Parking Brake or Cruise Control Malfunction Message with DTC C13B0

Service Category Brake

Section Brake Control/Dynamic Control System

YEAR(S)	MODEL(S)	ADDITIONAL INFORMATION
2019 - 2020	Avalon	VDS(s): AZ1FB, BZ1FB, CZ1FB, DZ1FB, EZ1FB, FZ1FB, GZ1FB, HZ1FB, JZ1FB

Figure 3. Location of Authorized Modifications Label on 2019 – 2020 Avalon

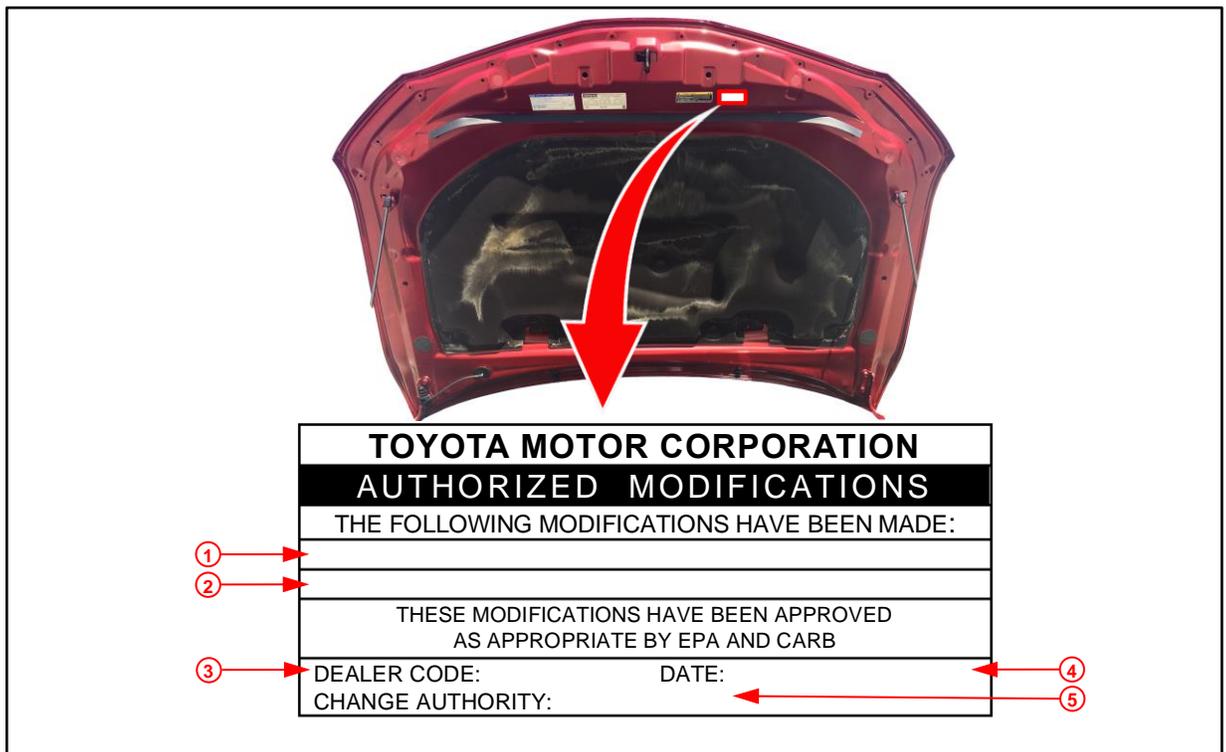
2. Does the Parking Brake Malfunction or Cruise Control Malfunction message go away (at least temporarily) after shutting off and restarting the vehicle?
 - **YES** — Continue to step 3.
 - **NO** — This bulletin does NOT apply. Continue diagnosis using the applicable Repair Manual.
3. Use Techstream to confirm if the skid control ECU calibration has been updated and check for the Authorized Modifications Label affixed to the vehicle in the location shown below.

5. Prepare and install the Authorized Modifications Label.
 - A. Using a permanent marker, enter the following information on the label:
 - ECM (PCM) part number [*Refer to the **Parts Information** section for the **NEW PART NUMBER***]
 - Calibration ID(s) [*Refer to the **Calibration Information** section for the **NEW CALIBRATION ID***]
 - Dealer Code
 - Repair Date
 - Change Authority [***This bulletin number***]
 - B. Install the Authorized Modifications Label onto the vehicle at the location shown in Figure 3. The Authorized Modifications Label is available through the MDC, P/N 00451-00001-LBL.
6. Test-drive the vehicle to confirm proper operation.
